Re: Response to EPA March 29 Comments on the
Informal Review Draft of the Lockheed Martin
The Dalles Facility Post-Closure Permit
ORD 052 221 025

DEQ Matrix Responding to EPA Comments and Listing Updates to Draft Permit

CERCLA LANDFILL GROUNDWATER ELEVATION MAP S AQUIFER, MARCH 2011

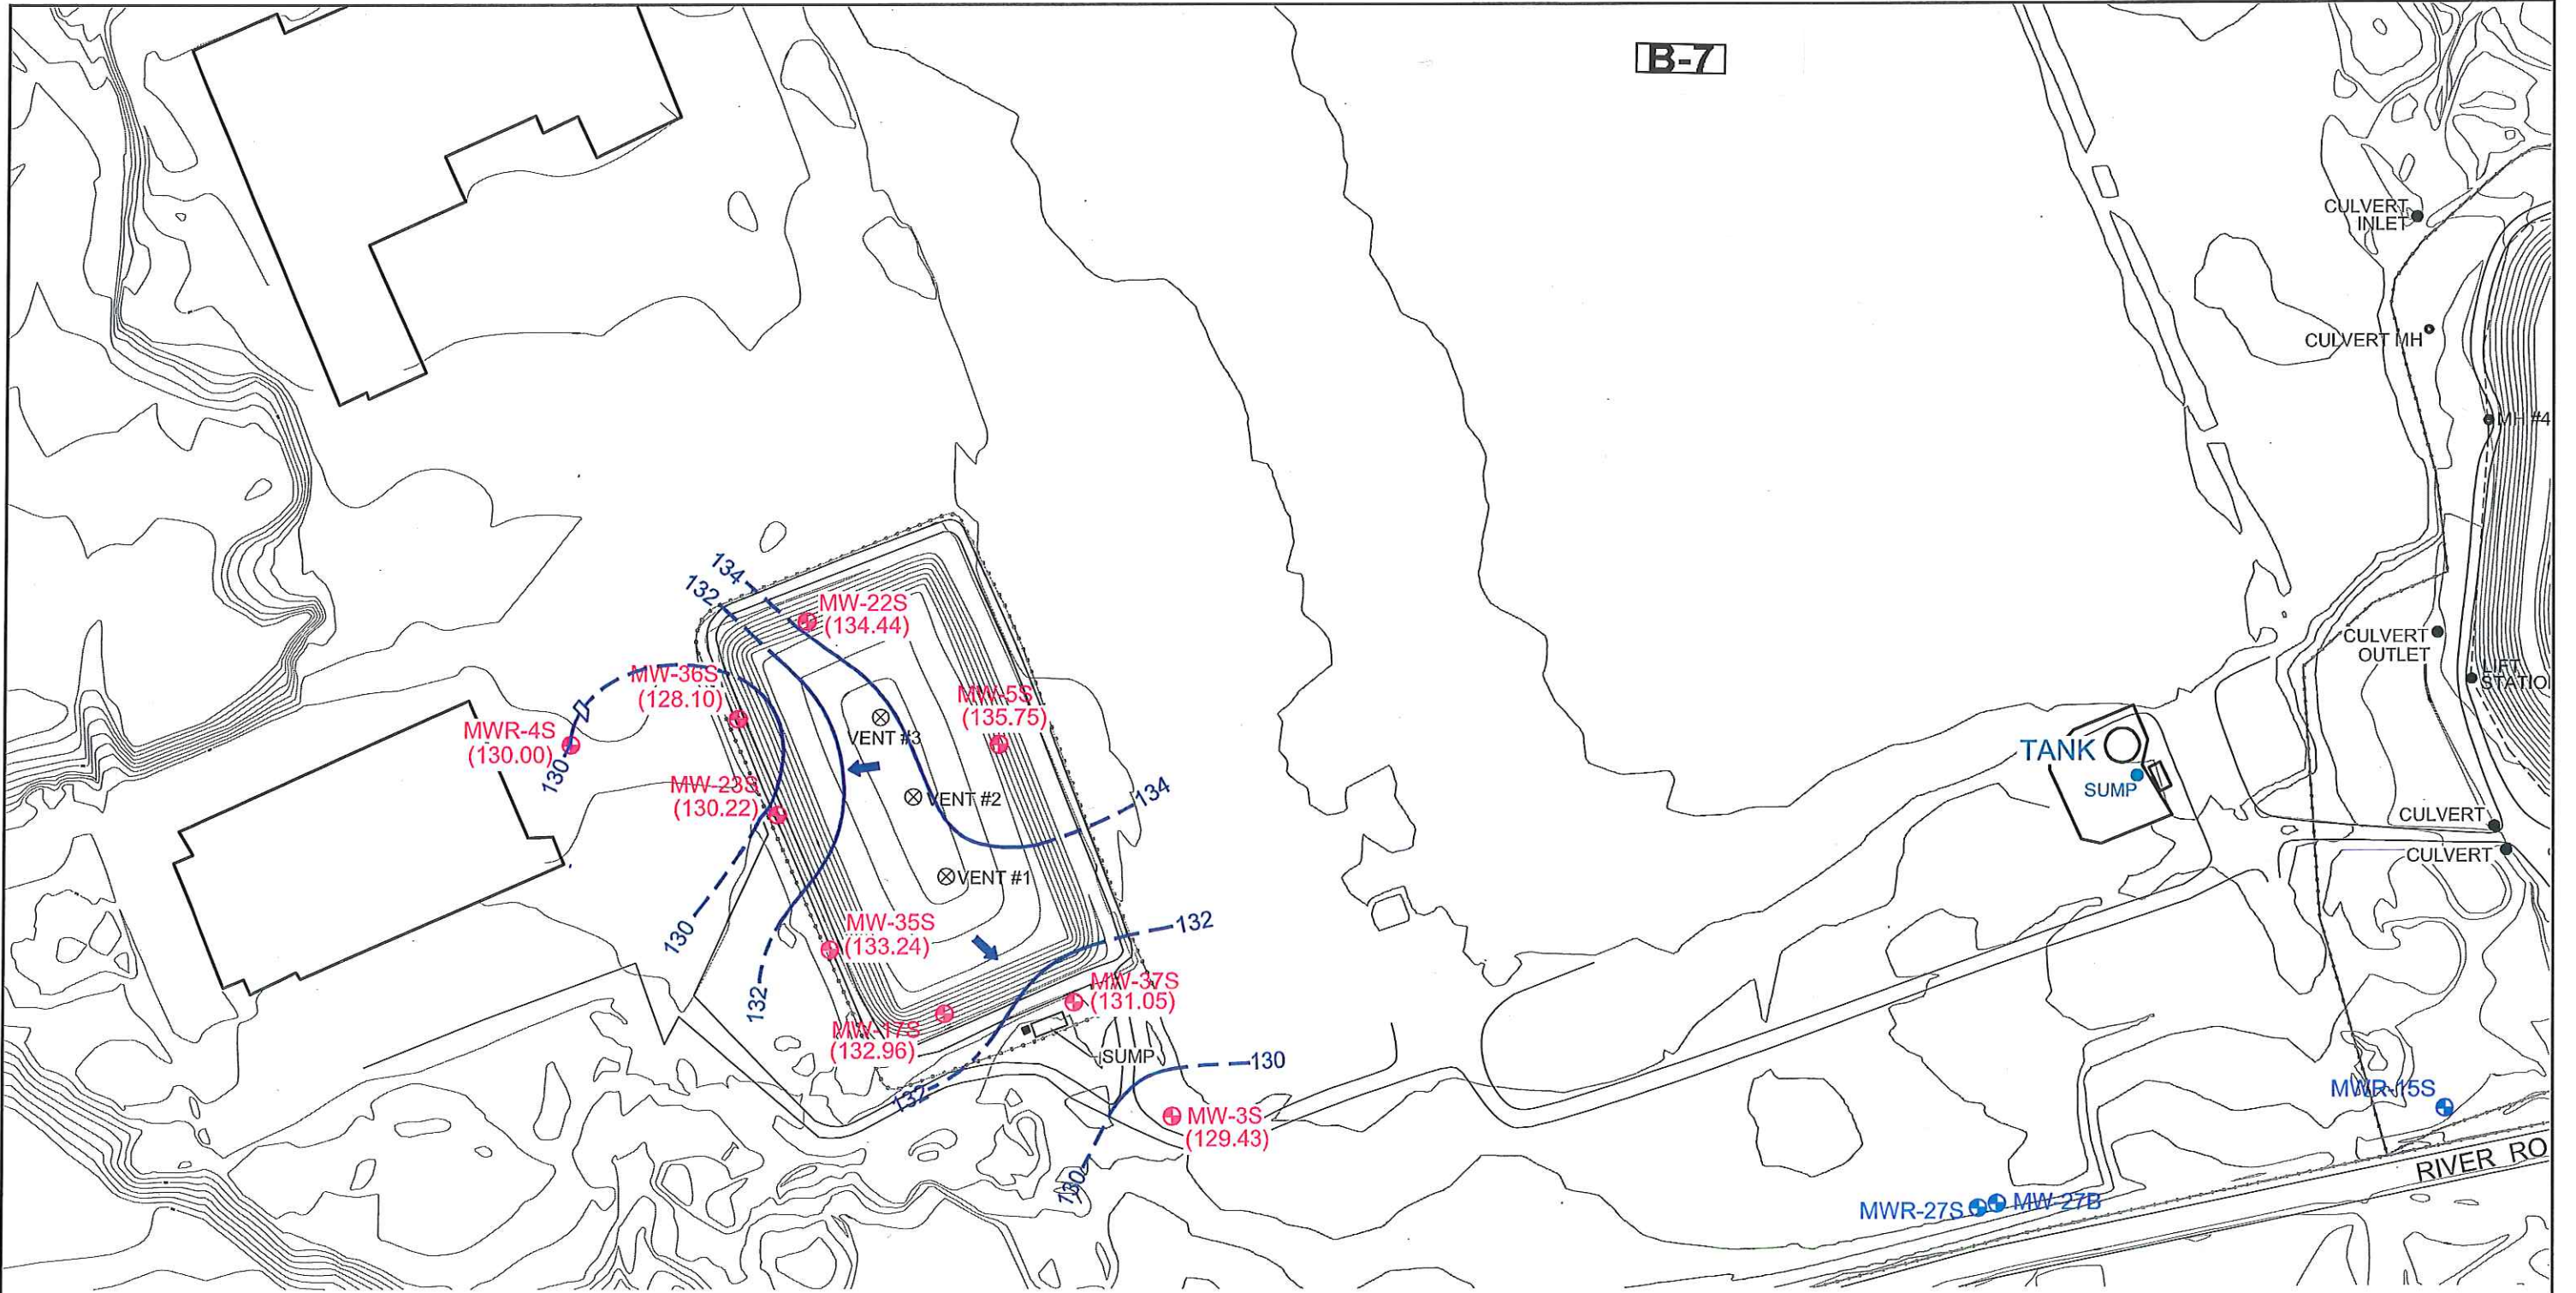
22	Section V.E should include specific generator language.		✓		See #14 above.
23	Permit should include figures with groundwater gradients.	✓			See enclosures B-6, B-7 and B-8.
24	A description of the wet test used during inspections should be included.	✓			See enclosures B-9 and B-10.
25	Post-Closure Plan should be substantially edited to avoid duplication, or at a minimum be reviewed for inconsistencies.		✓		DEQ has reviewed the post-closure plan for inconsistencies and finds it adequate.
Total		5	18	2	
UPDATES TO PERMIT FROM MARCH 20 EMAIL					
1	Add "40 CFR" to permit condition I.E.3.b.				See enclosure B-11.
2	Delete "significant" and delete "incorporation of the new object" with "change" at permit condition I.E.12.				See enclosure B-12.
3	Add summary table in Inspection				See enclosure B-13.
